Product Change Notification

Date Issued :	November 13, 2026	**PCN Number :**	518968
Reason for Change :	Packaging Method/Quantity Change		
PCN Subcategory:	PCQC - DU Change		
Description of Change :	This notification is to inform you that the part(s) listed in this notice will undergo changes to the delivery unit (DU) and shipping carton specifications. The carton dimensions, DU, and MLQ will increase. No changes will be made to the product as a result of this change. 1. By integrating the similar carton, we reduce the number of SKU(stock keeping unit) and improve management efficiency. 2.The Qty per carton will be increase. 3.Reduce SKU 4.Running change		
Reason for Short Notice :	Corrective Actions		
Assessment of Change :	No change to parts - Form/Fit/Function		
Planned Implementation Date :	June 30, 2027		
Customer Sample Availability Date:	February 25, 2027

Packaging Change

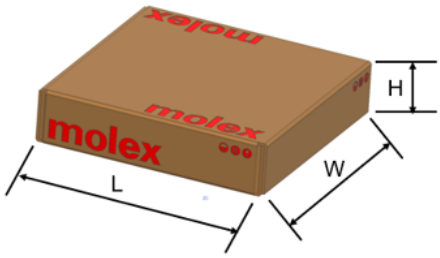
Before				After			
Carton	L	W	H	Carton	L	W	H
885961297	640	630	221	885961503	640	635	265
885961184	625	625	120	885961370	625	625	172
885960407	600	600	150	885961370	625	625	172
885961605	394	390	400	885960367	394	390	437

Before		After	
Reel	Diameter	Reel	Diameter
885960411	575	885961179	610

- Change description:
  - The shipping carton and paper reel change, the dimension will be increase.
- Product Impact
  - No impact to product, only shipping carton change, DU and MLQ will increase.
- PCN will be implemented once all required qualification/validation has been completed, and necessary approvals have been obtained
